Environmental impact assessment  
for the life extension and upgrading  
thermal power of Olkiluoto units 1 & 2

Project element: scoping

Bojan Tomic  
Ioana Popa  
Oana Velicu

Figure 2:  
Alternatives examined in  
the EIA procedure and  
their preliminary  
planned schedule

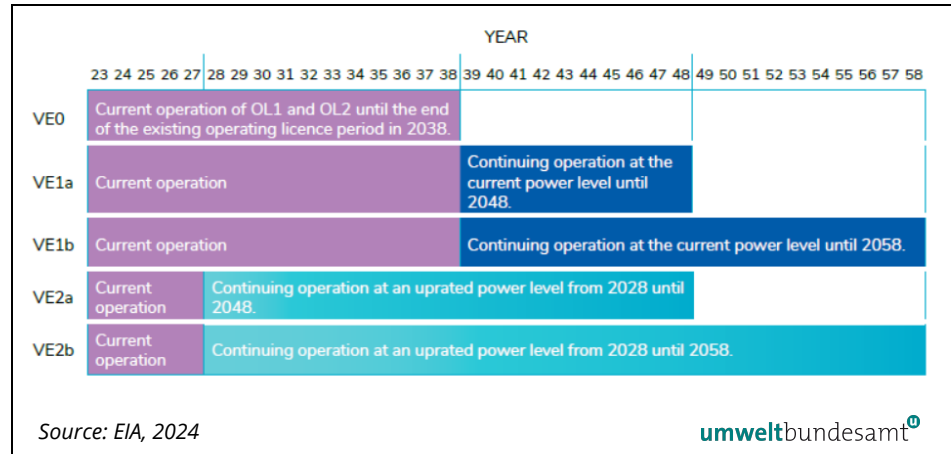
While the concept for different alternatives are clearly described and graphically depicted in a very clear and understandable way (as represented in the Graphic No. 2), the EIA programme document provides very little information in relation to what each of the alternatives would entail in the terms of technical requirements, eventually needed modernisation, improvements or changes of the design or the acceptance of the regulator.

1. For each of the alternative, the EIA report shall provide the detailed discussion on the technical basis, the safety assessment, the impact assessments as well as the basis and criteria that is being used to evaluate the alternatives that are being considered
2. Alternatives like new NPPs or non-nuclear electricity sources are also to be considered as an option
